THM 4T65-E UPDATE HANDBOOK

INTRODUCTION THM 4T65-E UPDATE HANDBOOK

Technical Service Information

Figure 40

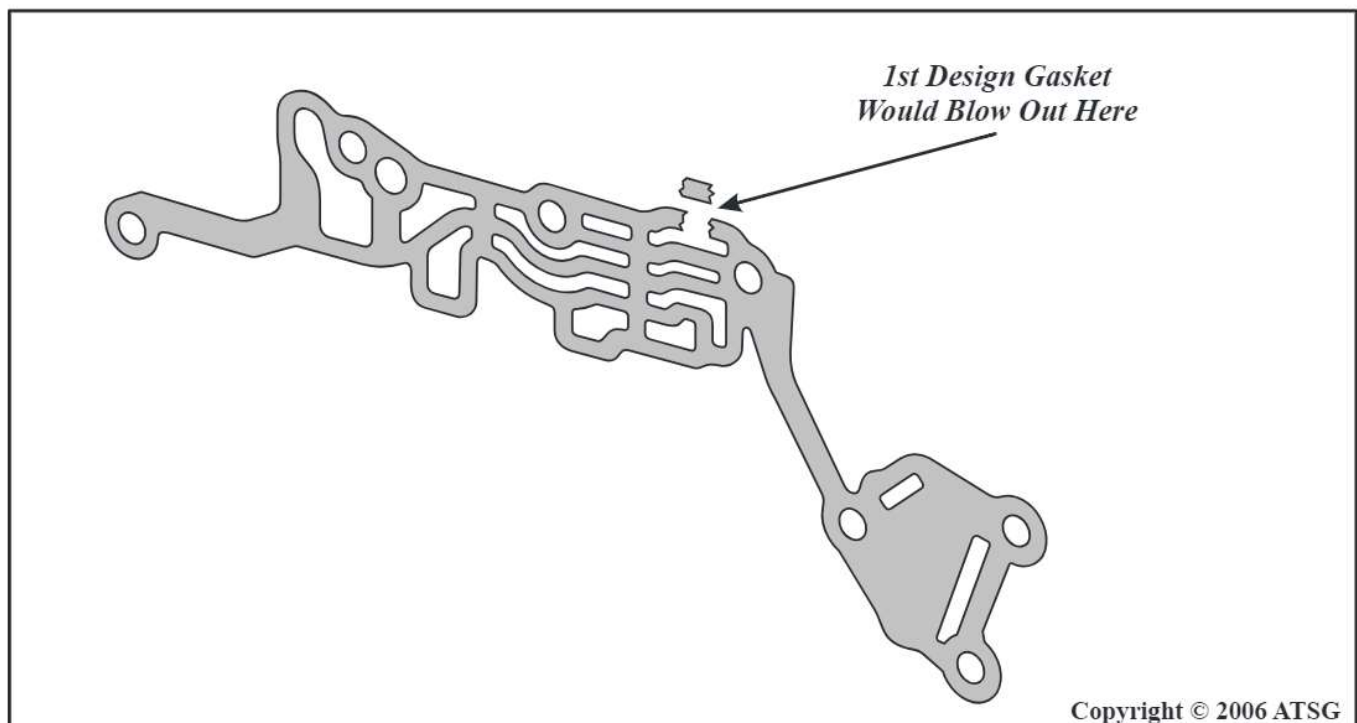
REASON: The 1st design gasket would "blow out", as illustrated in Figure 40, which would allow full line pressure to be aimed right at the vent, and this was not a good thing. The top passage was eliminated in the 2nd design gasket, as shown in Figure 41. Unfortunately, this created more concerns of gaskets blown out due to excessive pressure. This required the 3rd design gasket which now has 2 slots in this area, as shown in Figure 41.

Figure 41

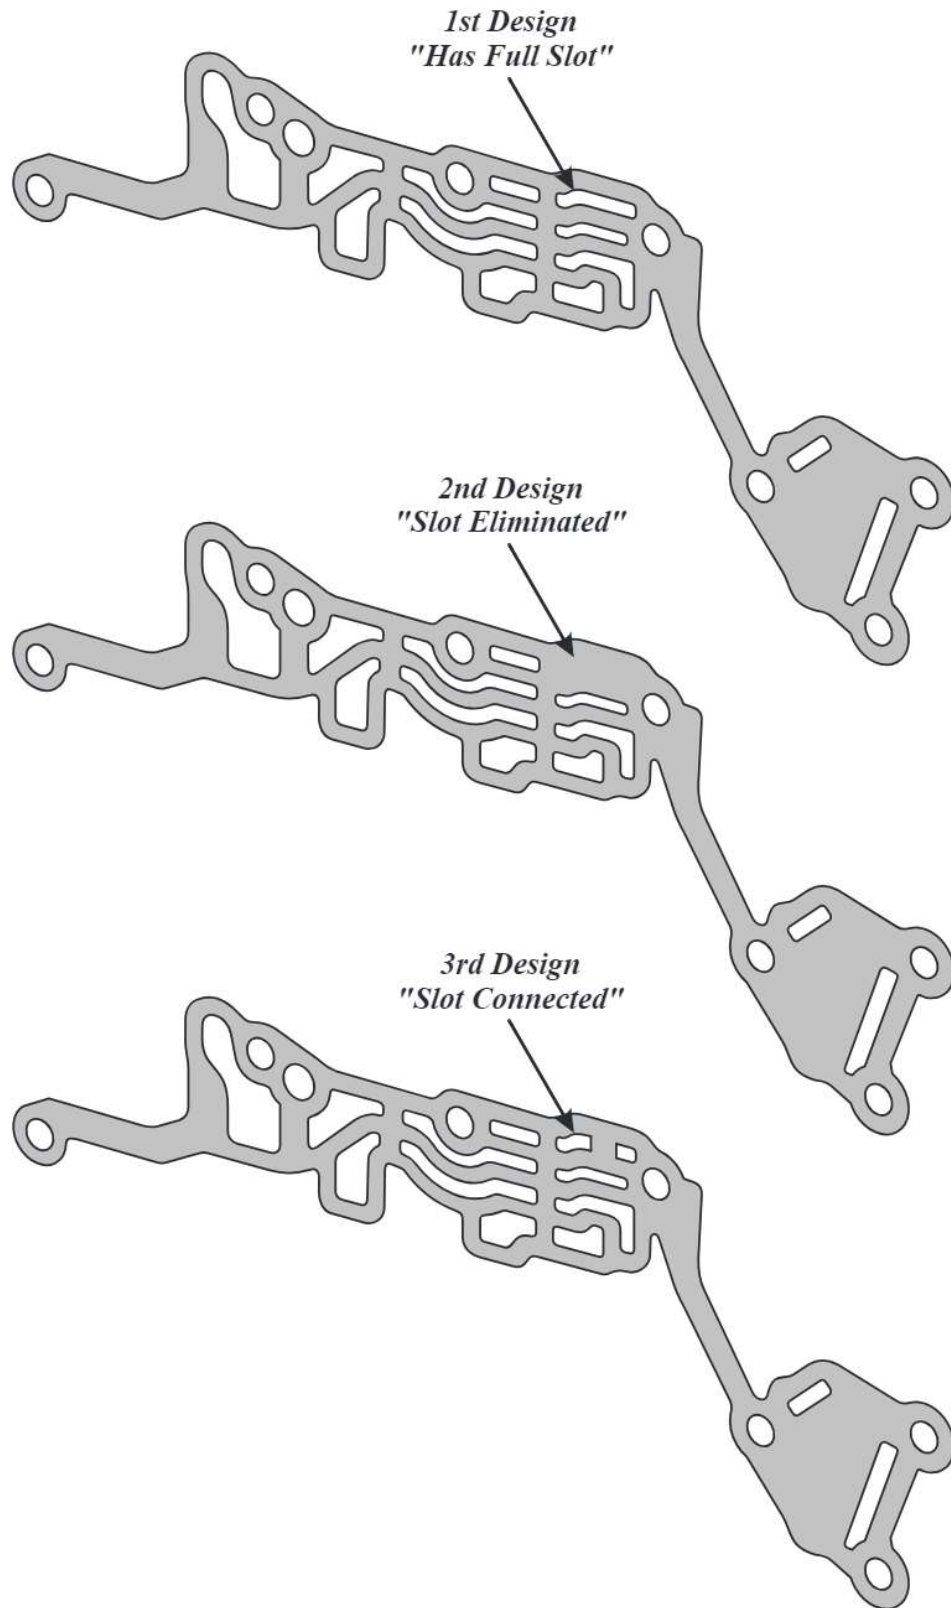
CHANGE: The upper channel plate gasket has now been changed twice which now creates three different design levels. All three design levels are illustrated in Figure 41.

- (1) UPPER CHANNEL PLATE GASKET - In the 3rd design gasket GM engineering has added 2 slots to improve fluid flow, as shown in Figure 41.

This was a running change at the assembly plant, and the 3rd design gasket will replace all previous gaskets for all models (See Figure 41). The 3rd design gasket is now included in the aftermarket gasket sets.

Figure 42

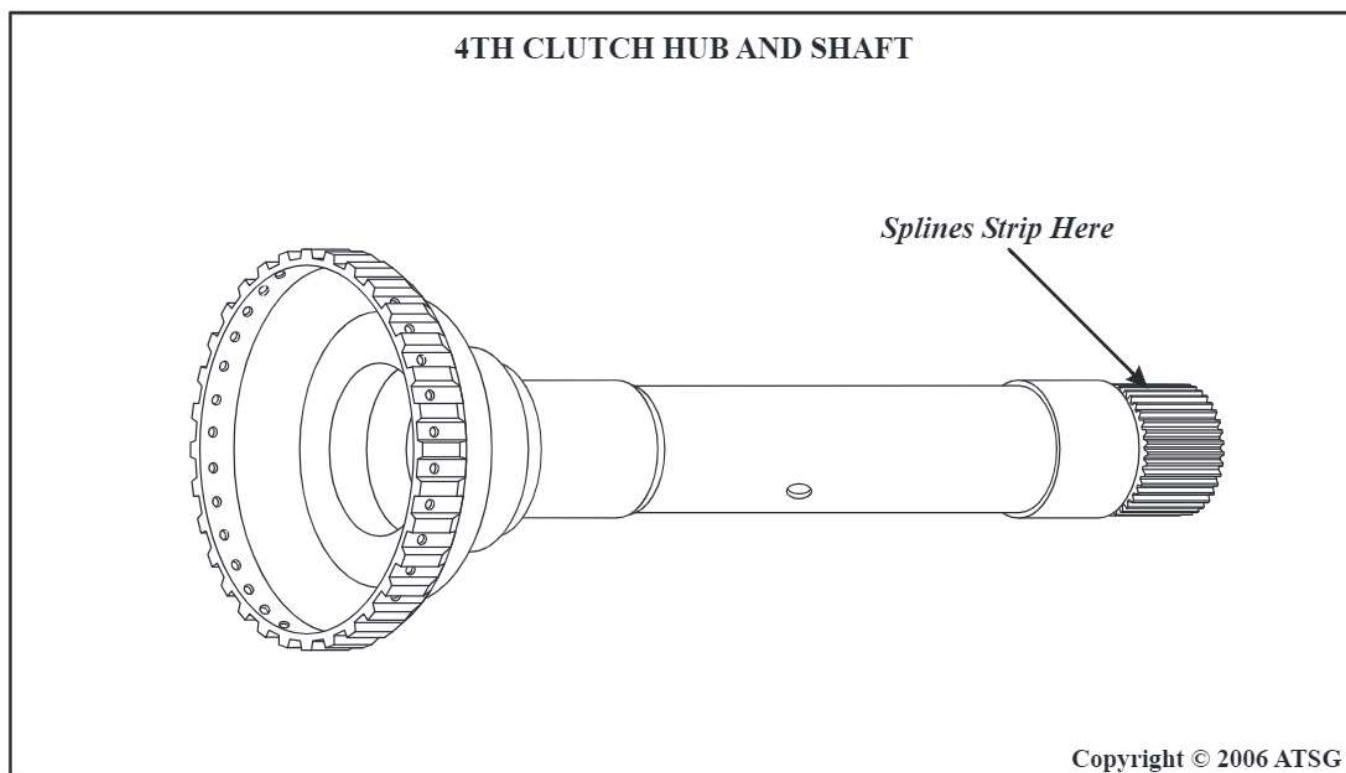
CAUSE: The cause may be, stripped splines on the 4th clutch hub and shaft where it splines into the input sun gear, as shown in Figure 42.

4th Clutch Hub and Shaft 24205603

Figure 43

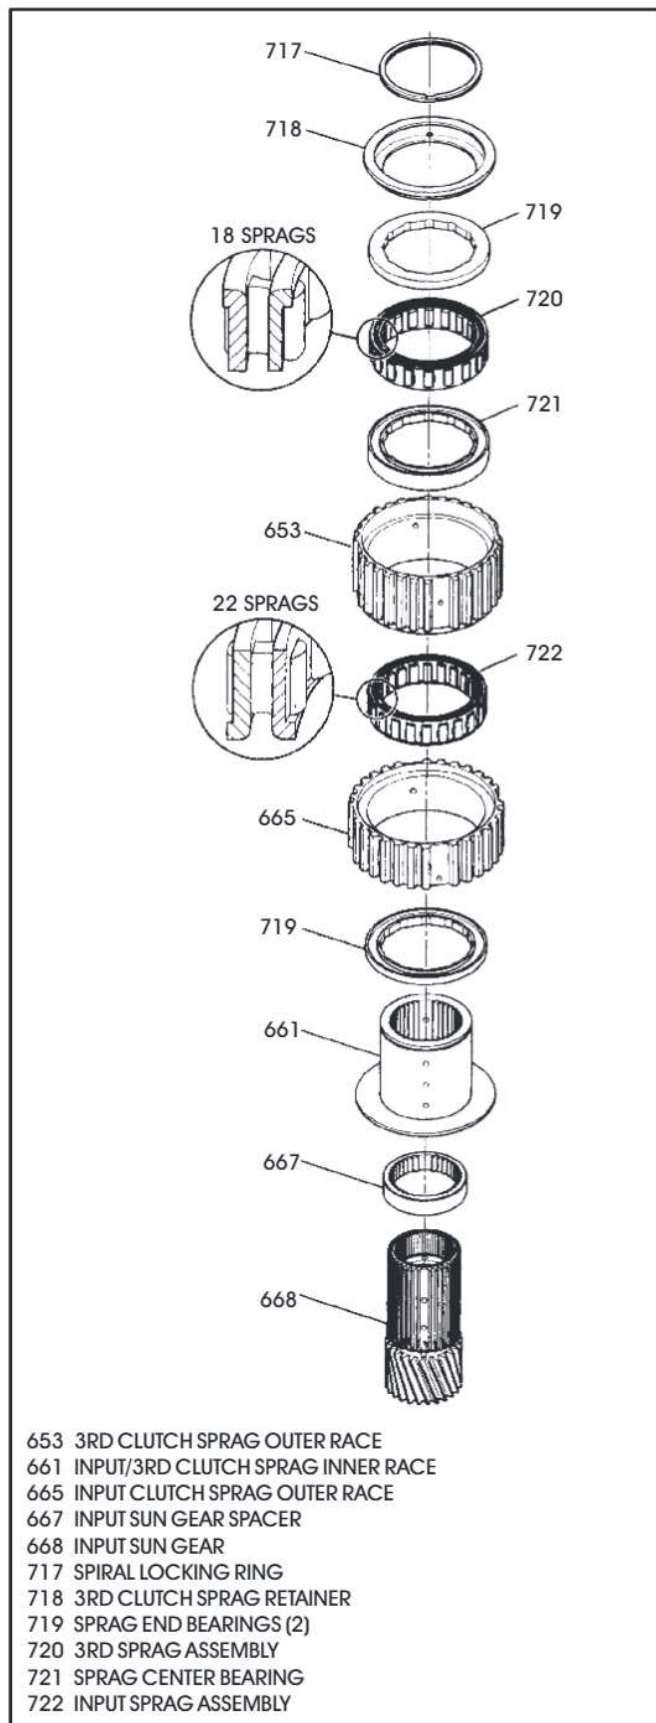
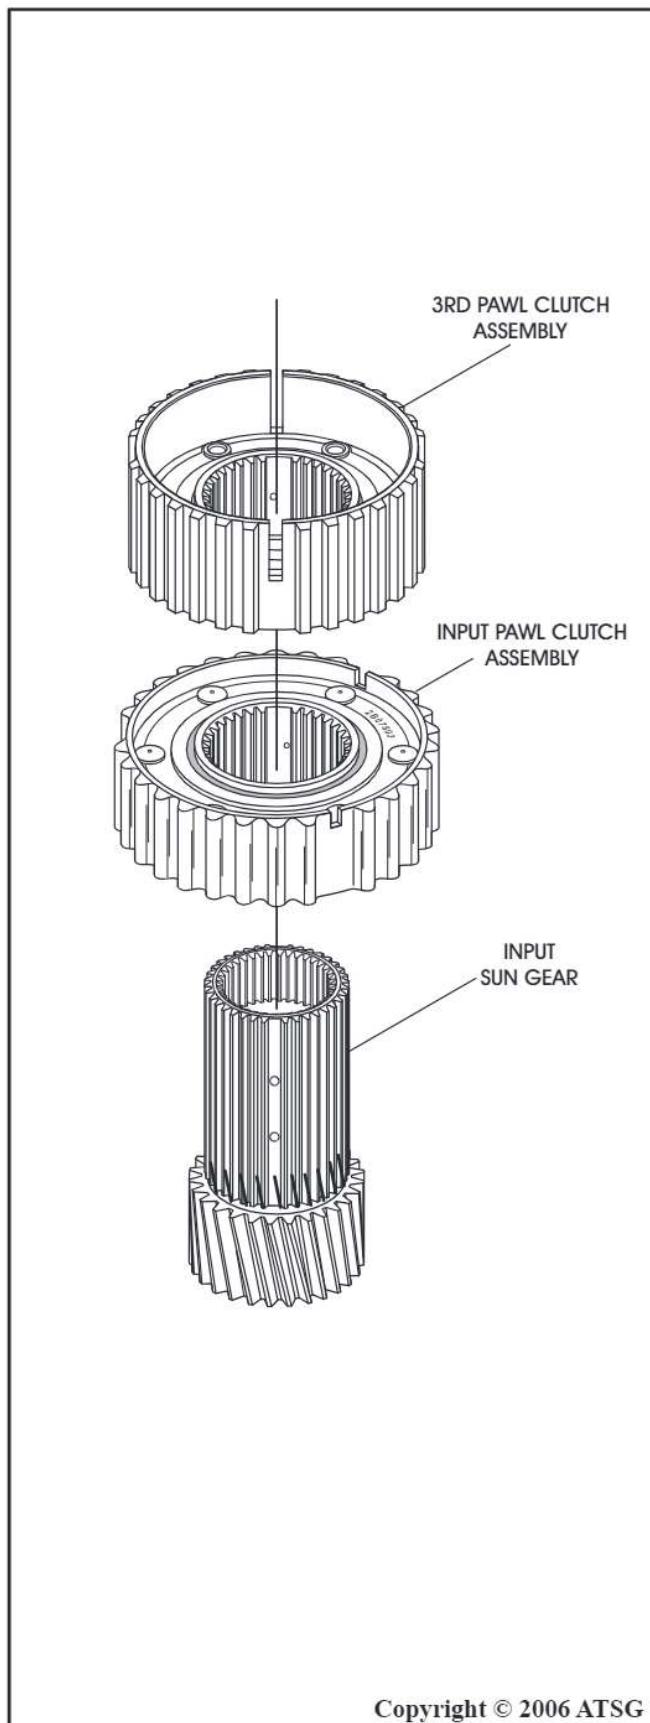
CHANGE: Some 2003 model THM 4T65-E transaxles will come equipped with a newly designed Input and Third "Pawl" Clutch Assembly instead of the previous design Input and Third Sprag Clutch, as shown in Figures 43 and 44. This was implemented at start of production for the 2003 model year.

- (1) INPUT "PAWL" CLUTCH - The new design outer race has 30 splines instead of the previous 32 on the Input Sprag and cannot be disassembled like the previous design Sprag Clutch, which obviously makes the assembly process easier. Refer to Figures 43 and 44 for illustrations of both designs.
- (2) INPUT CLUTCH FIBER PLATE - The new design fiber plate has 30 teeth instead of the previous design 32 teeth, to accommodate the new design "Pawl" Clutch Assembly. Refer to Figure 45 for illustrations of both designs.
- (3) THIRD "PAWL" CLUTCH - The new design cannot be disassembled, like the previous design Sprag Clutch, which obviously makes the assembly process easier. Refer to Figures 43 and 44 for illustrations of both designs. The third clutch fiber plates remain the same as previous models.

Figure 47

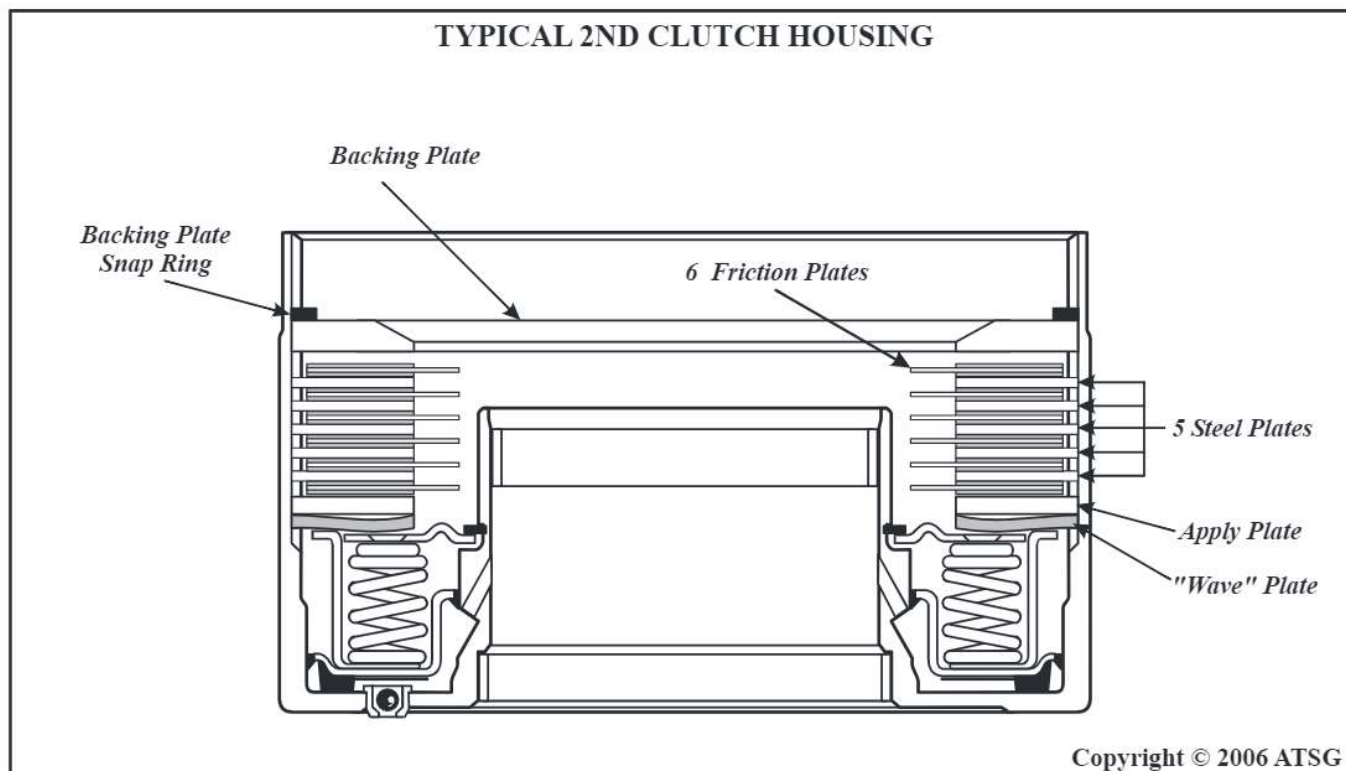
The 2nd clutch assembly has 6 friction plates, 5 steel plates and 1 wave plate, as shown in the housing cut-away in Figure 47. Referring back to the "general rule", this means that our preferred 2nd clutch clearance should be .048"-.072". The OEM steel plates are .068" thick. If the 2nd clutch clearance is .116" or more, adding an extra steel plate on top of the wave plate may be all that is needed to correct this concern.

Figure 48

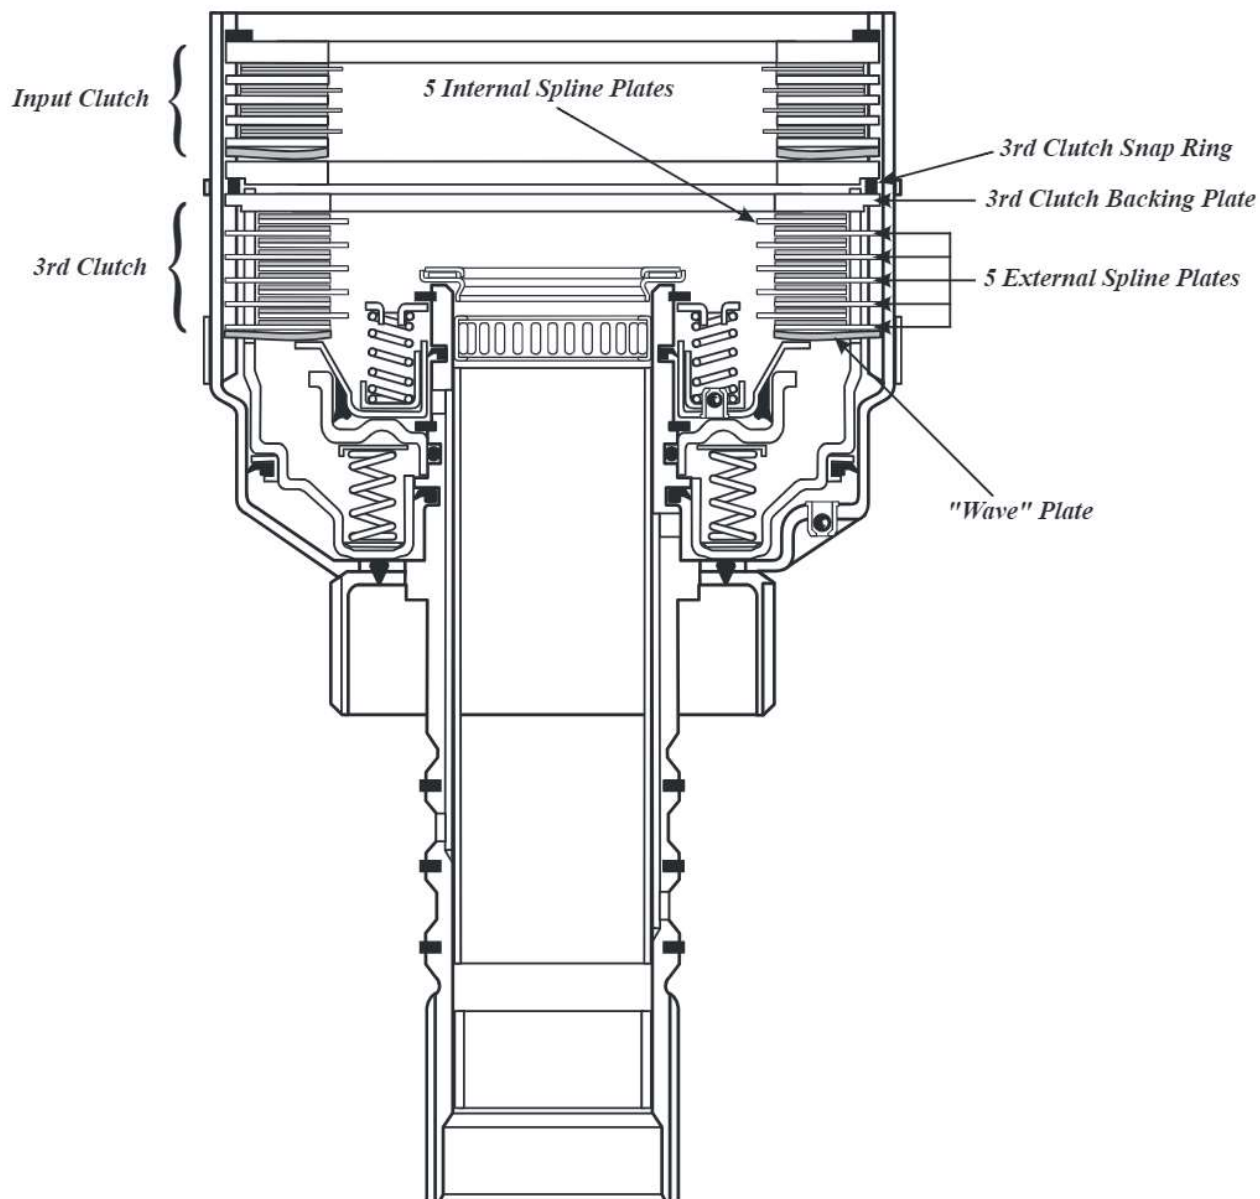
The 3rd clutch assembly has 5 "Single Sided" driving plates (external spline), and 5 "Single Sided" driven plates (internal spline), and 1 wave plate, as shown in the housing cut-away in Figure 48. Referring back to the "general rule", this means that our preferred 3rd clutch clearance should be .040"-.060". The OEM driving plates are .076" in total thickness with the steel core measuring .048". The OEM driven plates are .082" in total thickness with the steel core measuring .050". If the 3rd clutch clearance is .088" or more, you could remove the friction material from one extra external spline driving plate and place it on top of the wave plate first, and then add the normal stack of drive and driven "Single Sided" plates. Another possibility is substituting various model 4T60-E or 440-T4 3rd clutch plates until the preferred clutch clearance is obtained.

Figure 49

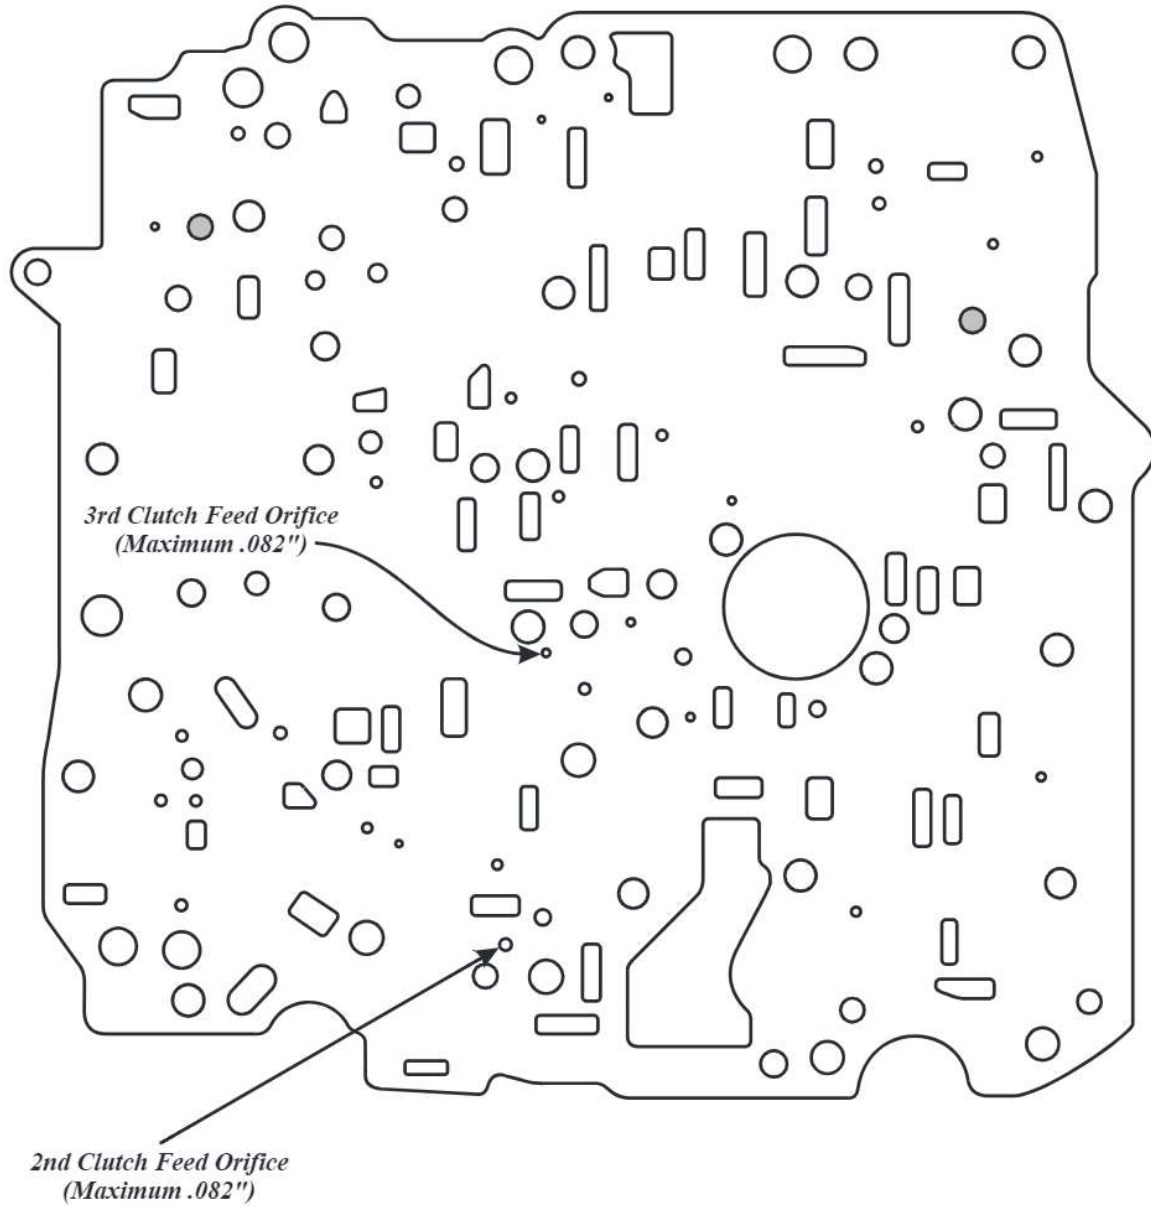
Further modification to the valve body spacer plate can also be made to allow the 2nd clutch and 3rd clutch cavities to fill quicker. Opening the 2nd and/or 3rd clutch feed orifices in the spacer plate .010" larger than original, as shown in Figure 49, will also allow a larger volume of oil the the clutch pack. The original orifice size is .070".

Special Note: Spacer plate orifice modification is not a recommended procedure as part of a normal overhaul. *This should be considered as an option, only after all other possibilities have been eliminated. Never exceed .082" total orifice size.*
